To: All Prospective Bidders
Re: Plyler Park Renovation
Date: January 2018

We would like to take this opportunity to inform you that the Plyler Park Renovation Invitation for Bid (IFB #18-B0073) has been cancelled in its entirety. We would also like to inform you that a new Invitation for Bid (IFB #18-B0094) for the Plyler Park Renovation project has been created. The Plyler Park Renovation Drawings, Addenda 1 thru 8 and revised Specifications associated with IFB #18-B0073, as well as this Cover Sheet outlining applicable information, shall hereby be incorporated and be made part of this current Invitation for Bid (IFB #18-B0094).

Plyler Park Renovation

Questions and Answers
Pre-Bid Conference for Plyer Park Renovation
December 8, 2017

ADDENDUM 2 - DRAWING 1

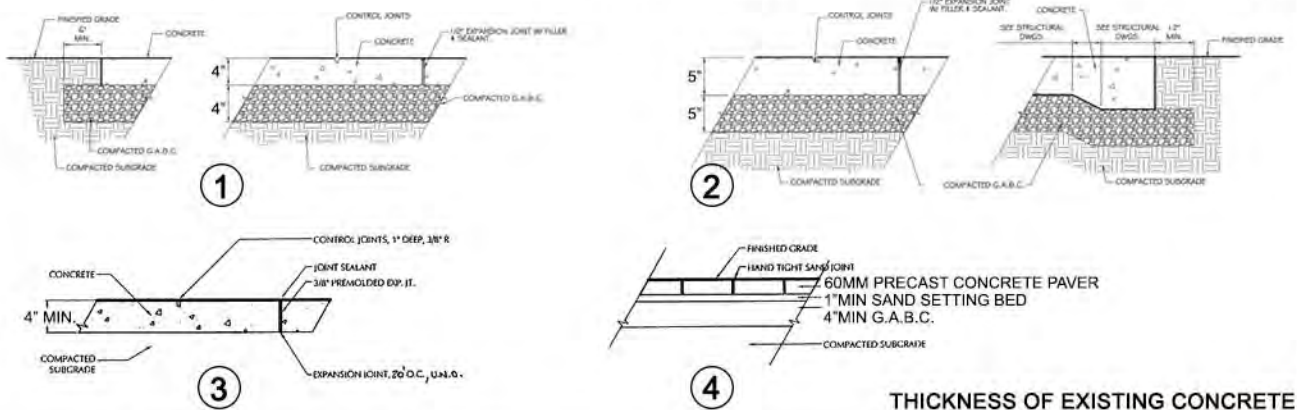
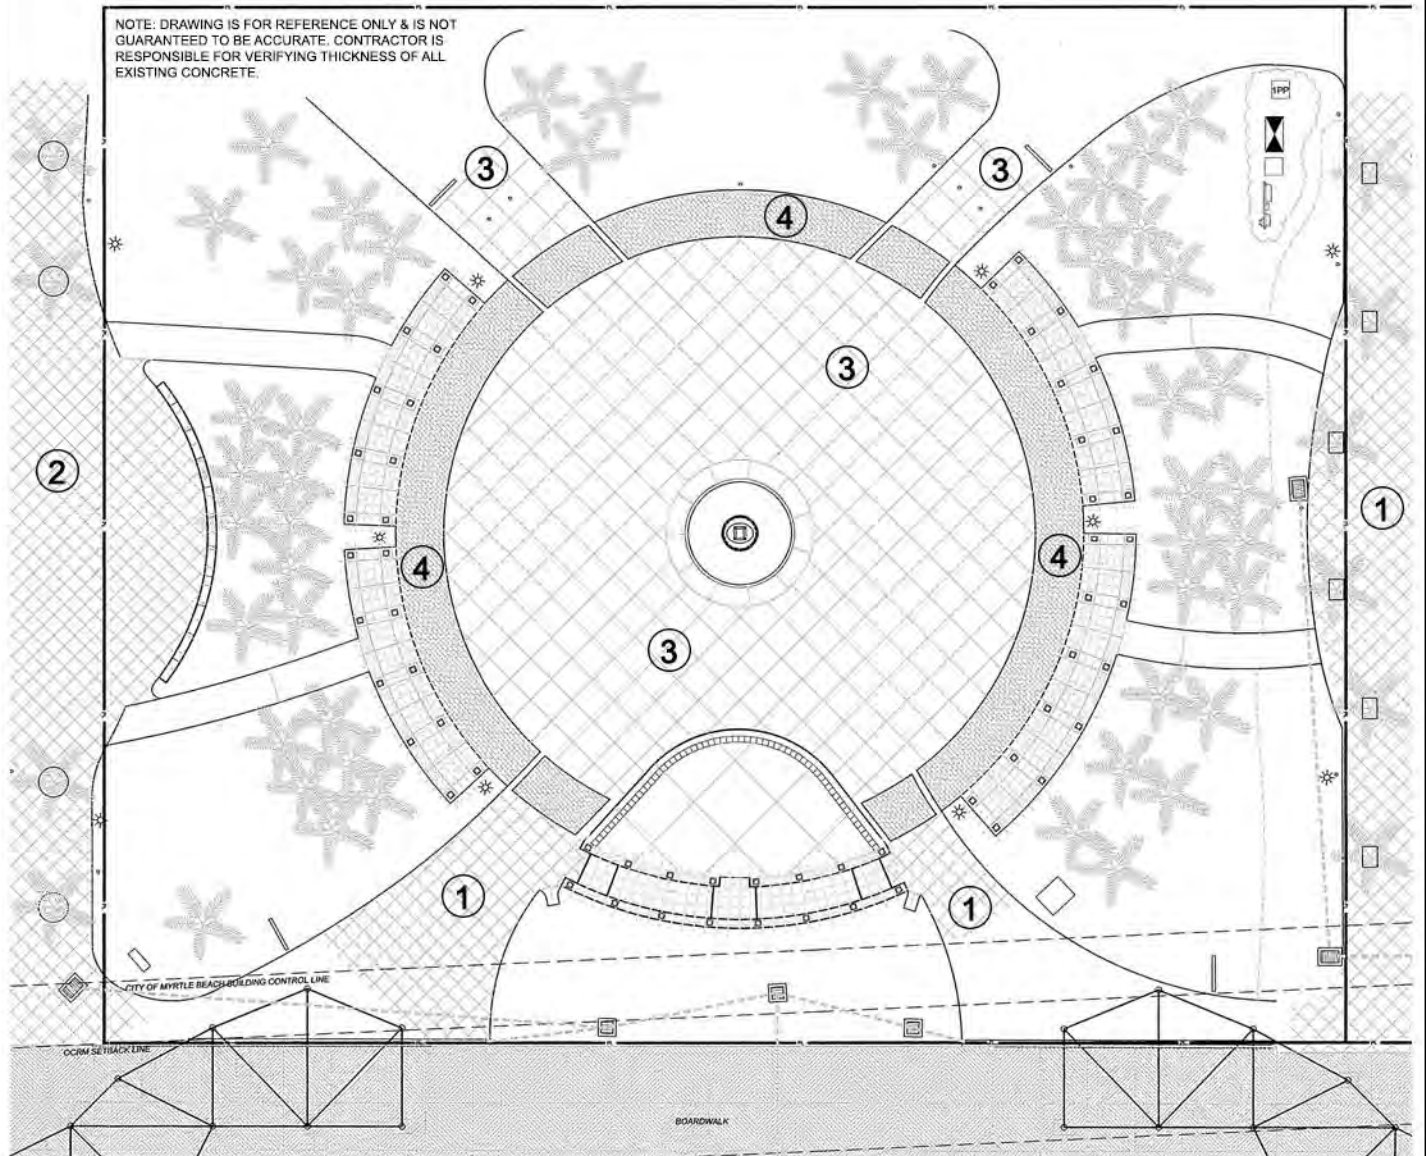
3. Q: Does anyone know the thickness of the existing concrete?

A: The thickness of existing concrete varies by location. Please see Addendum 1 - Drawing 1 for clarification. This Drawing should be used for reference only. Contractor is responsible for verifying thickness of all existing concrete.

NOTE: DRAWING IS FOR REFERENCE ONLY & IS NOT GUARANTEED TO BE ACCURATE. CONTRACTOR IS RESPONSIBLE FOR VERIFYING THICKNESS OF ALL EXISTING CONCRETE.

ADDENDUM 5 DRAWING 1

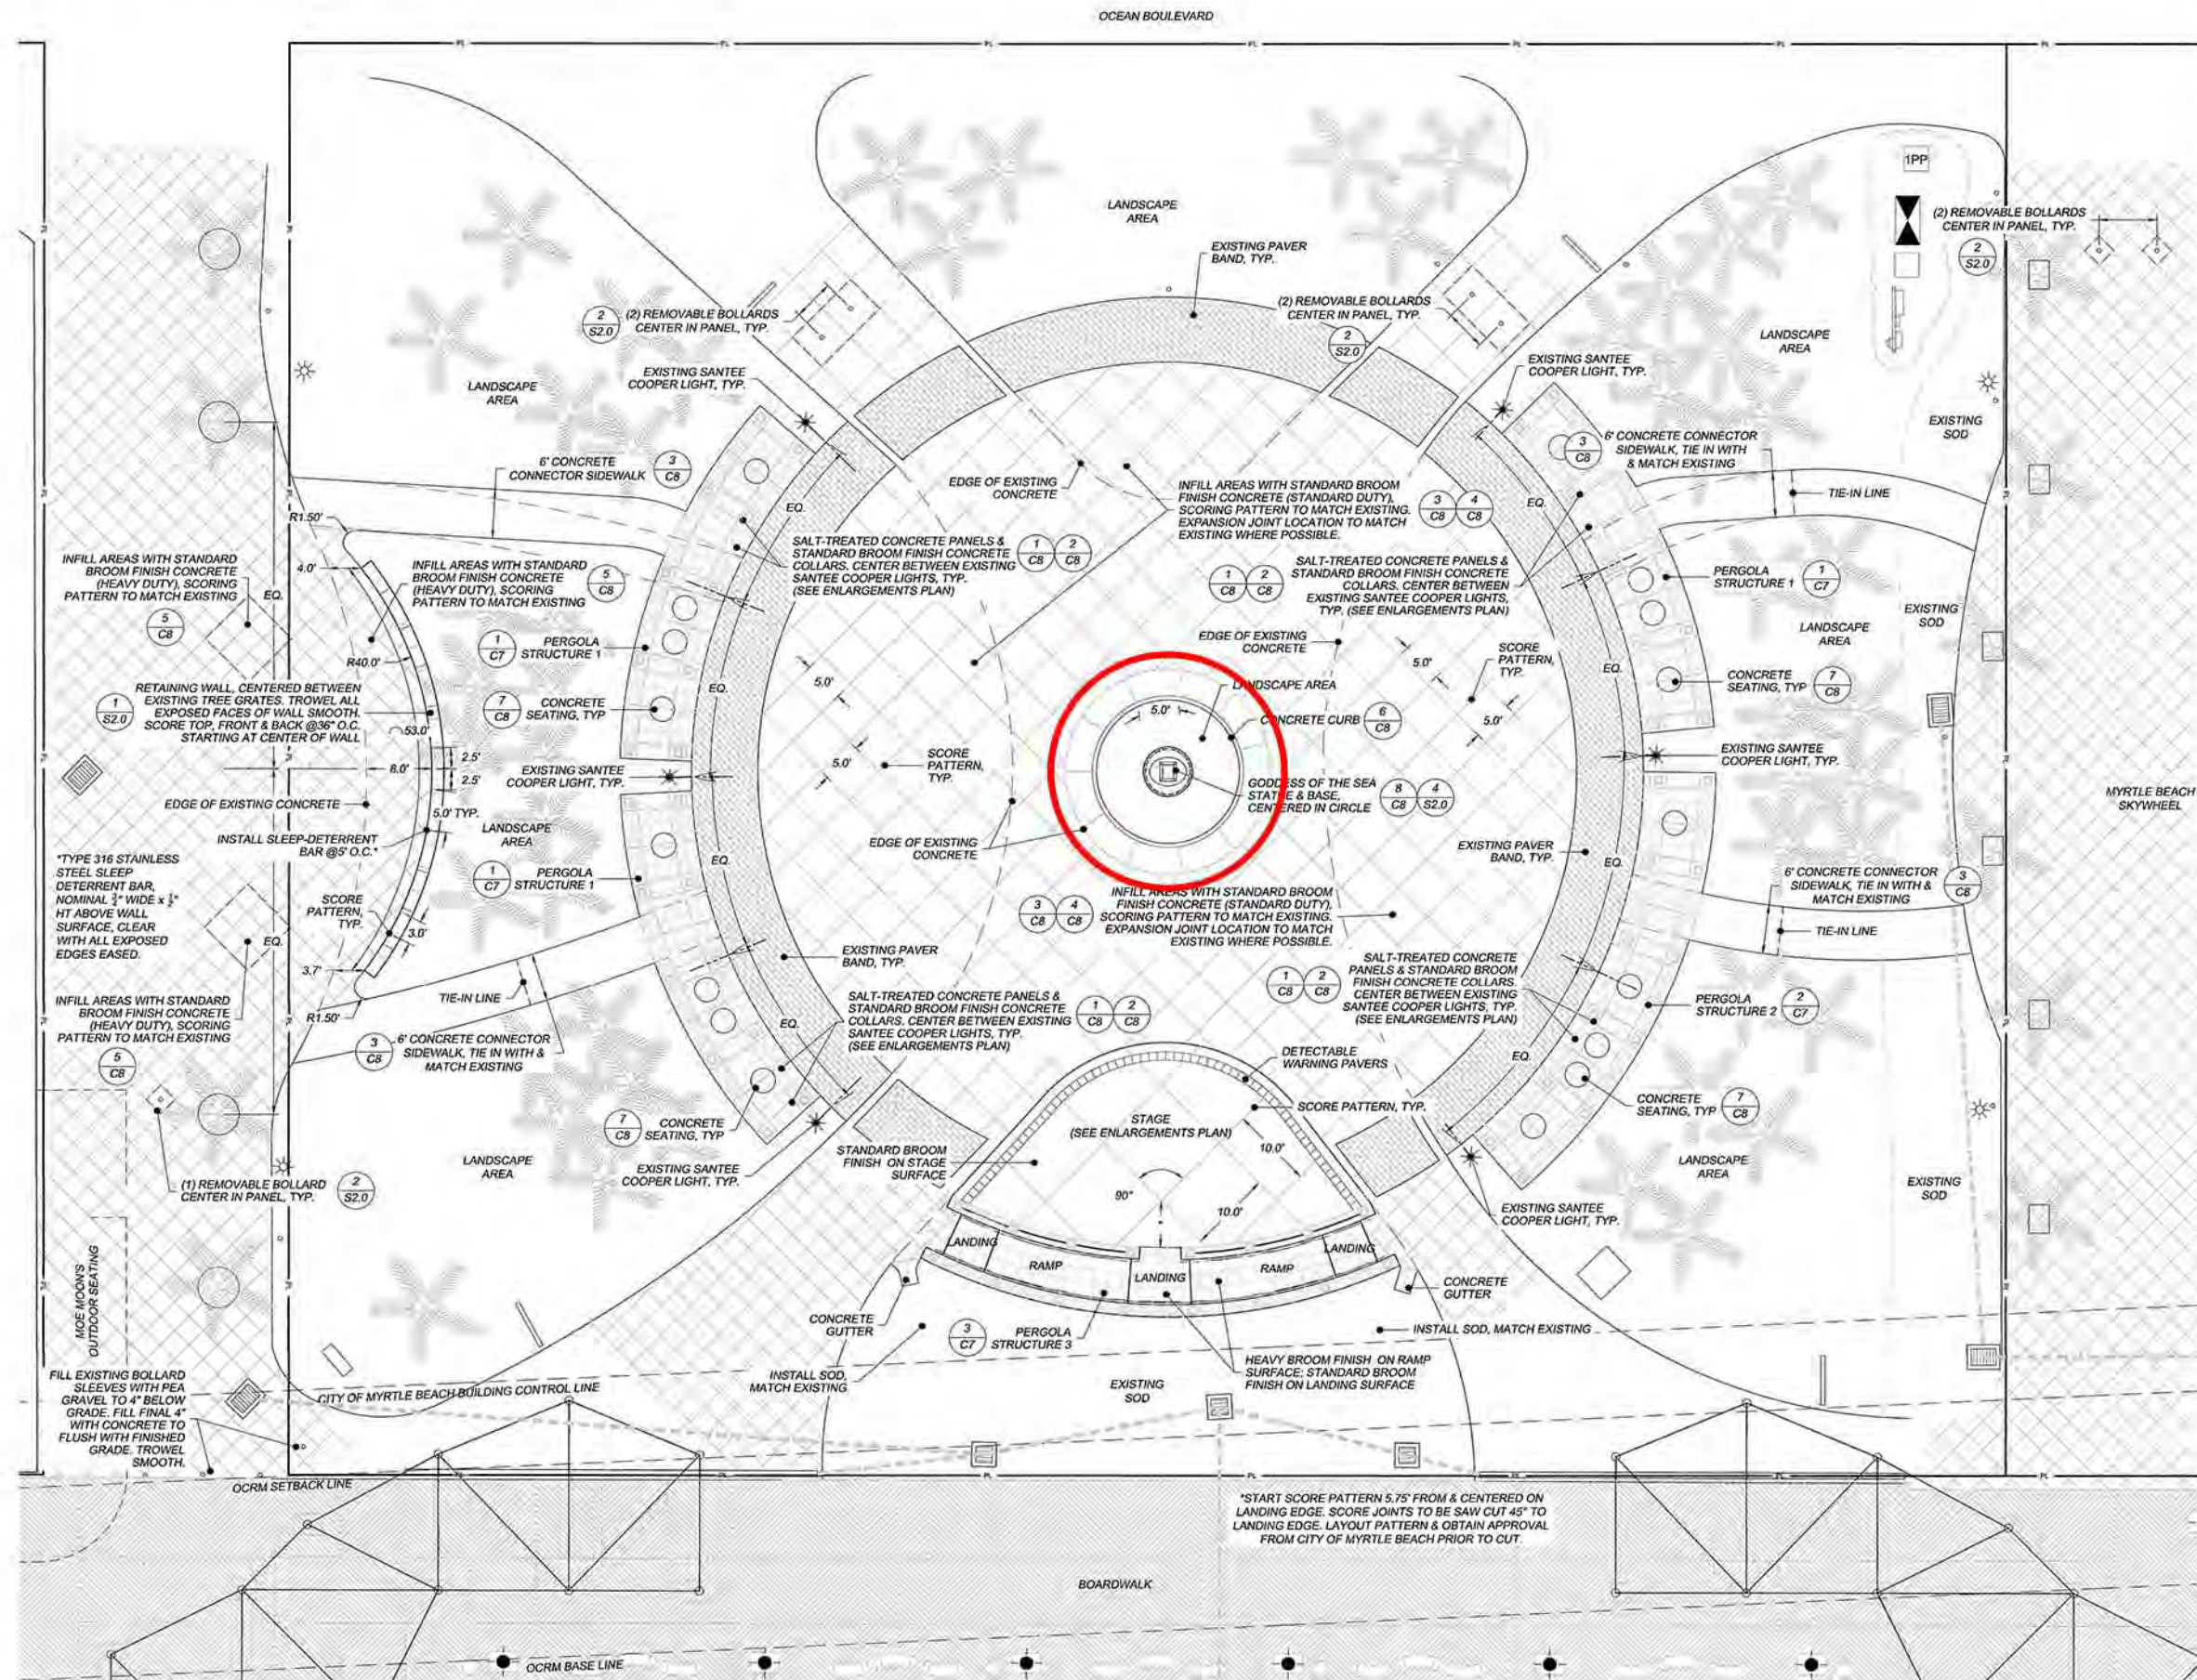
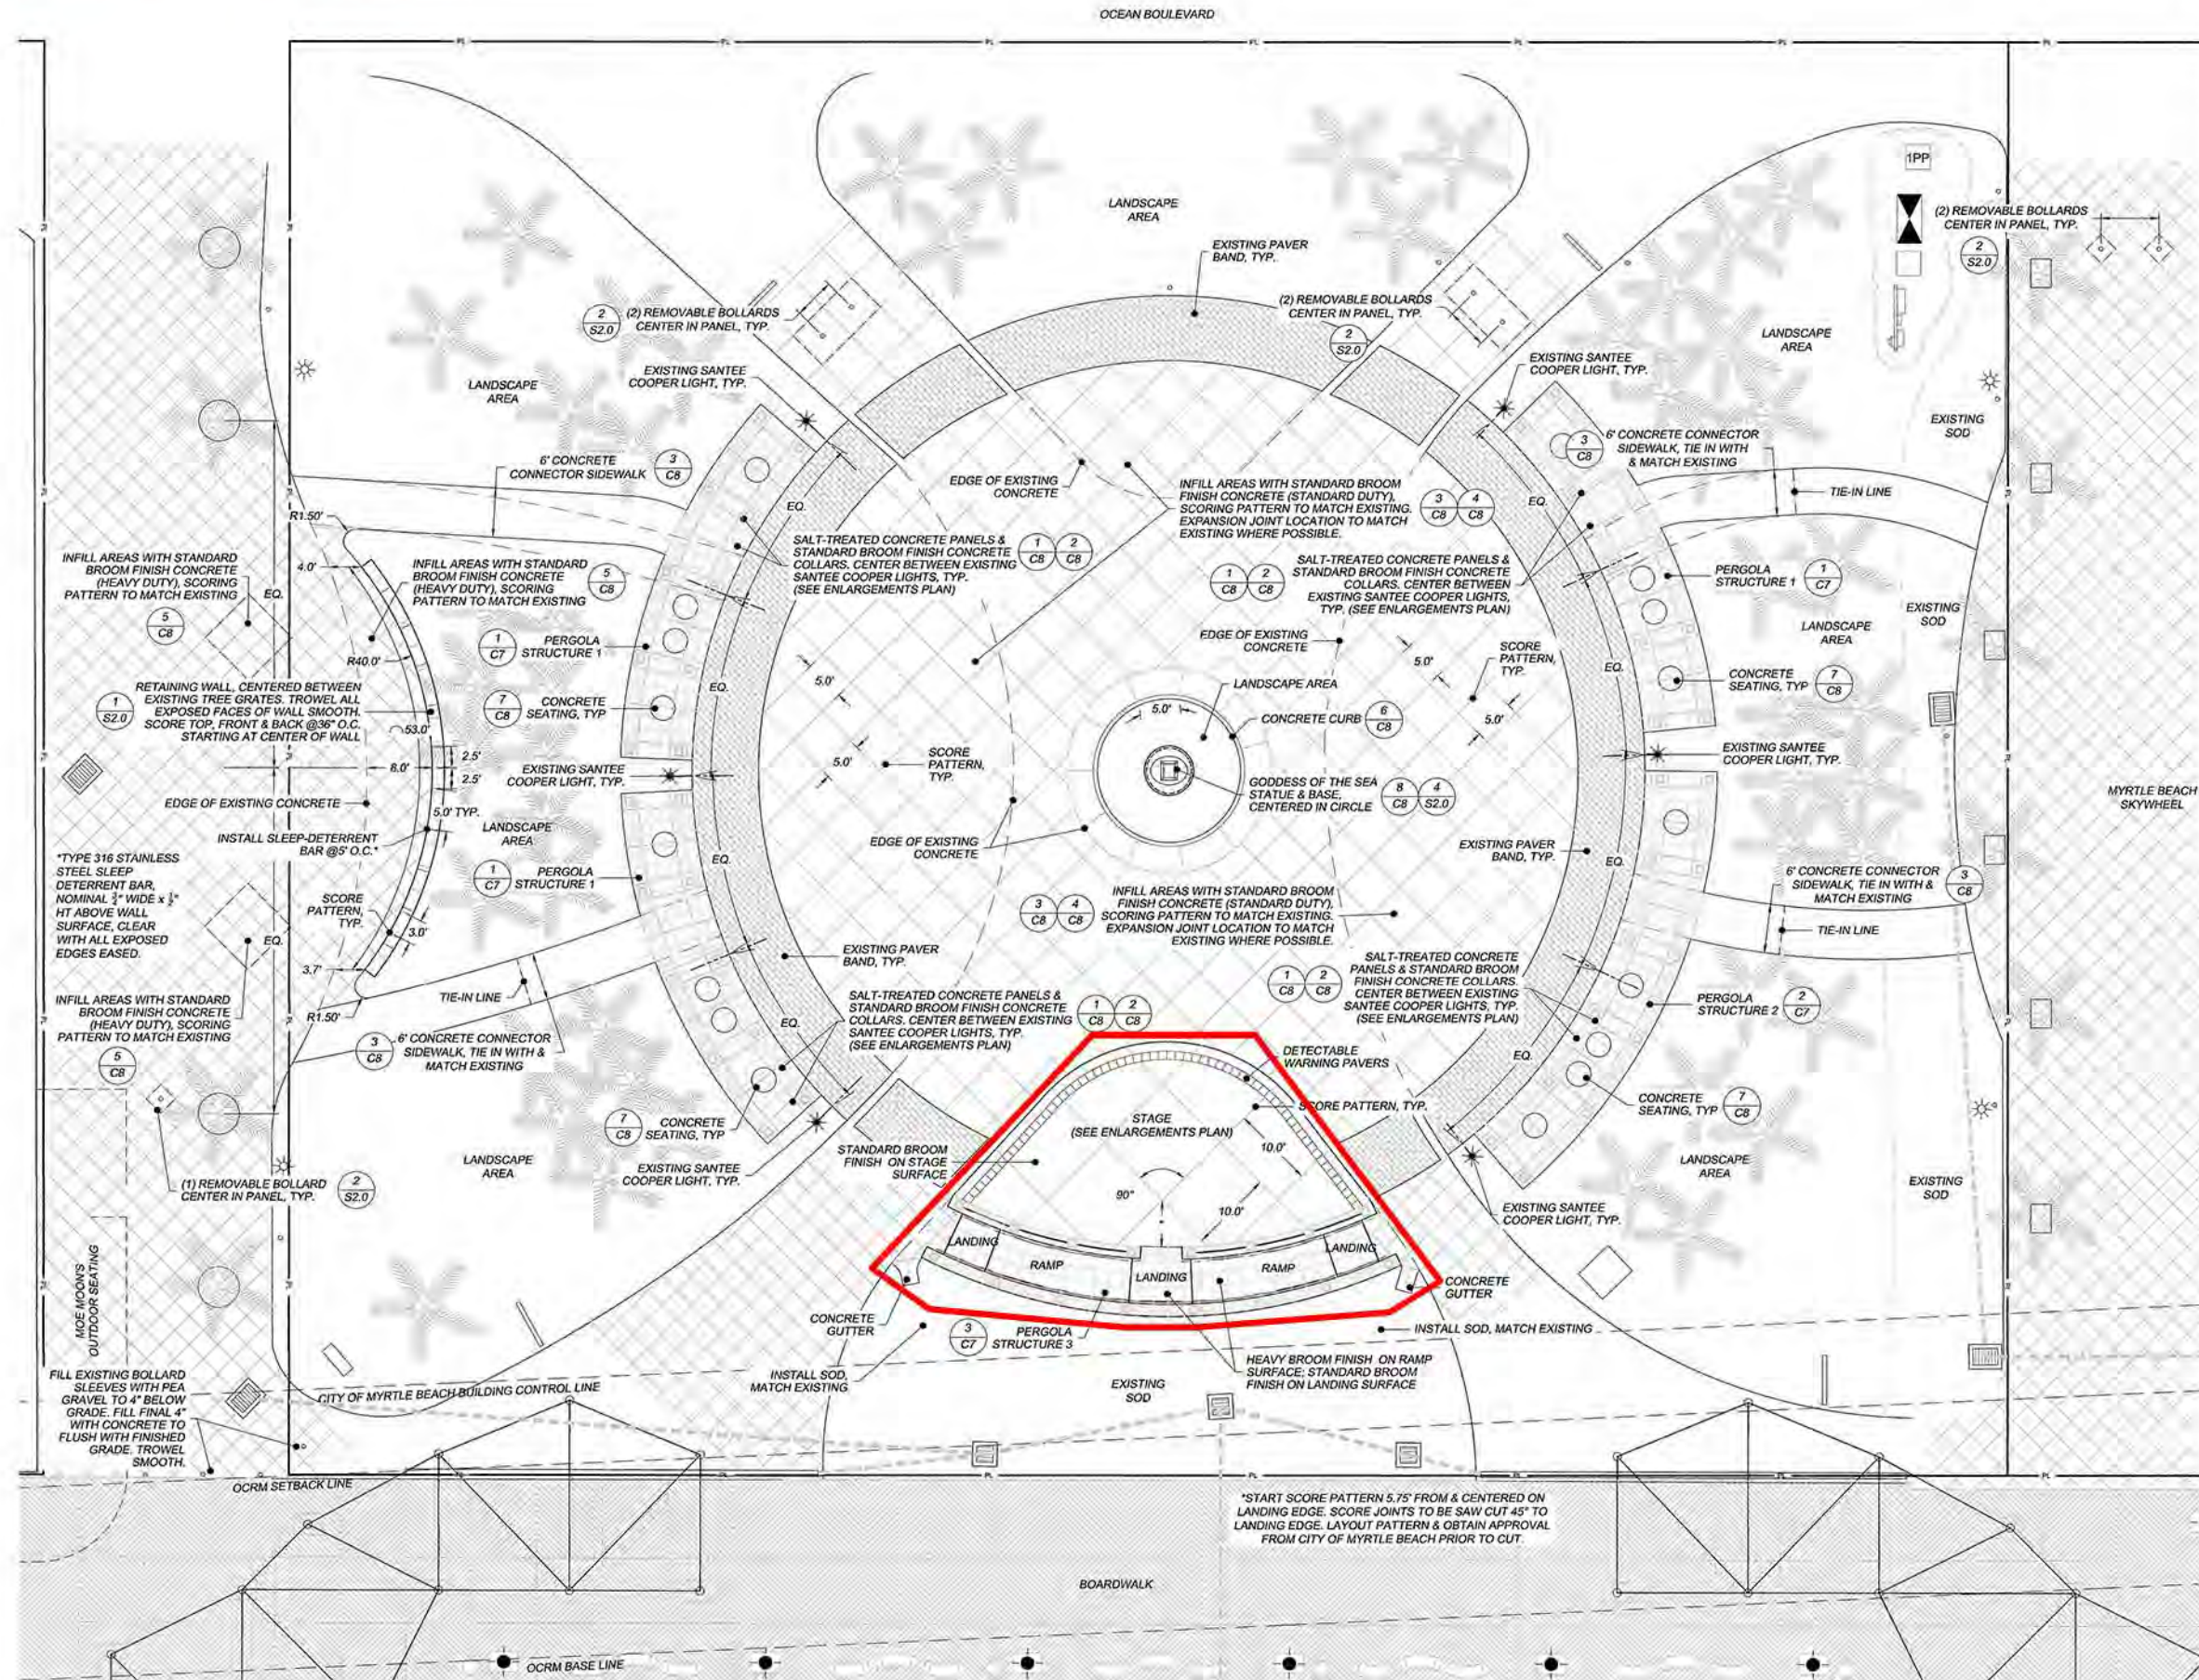
5. Q: Landscaping - No plans to tell us what to plant.

Please see attached for L1, L2 and the revised irrigation sheets. Also, see revised plan and notes on E1.0 and attachment for fixture specification. Fixture shall be 18W 4000K color temperature with black finish. Contractor shall replace existing Drawing and Addendum #3 clarification item with the revised Drawing.

A: No plant material, with the exception of a small amount of sod behind the stage, is included in this contract. Please refer to C4 for direction in the landscape areas.
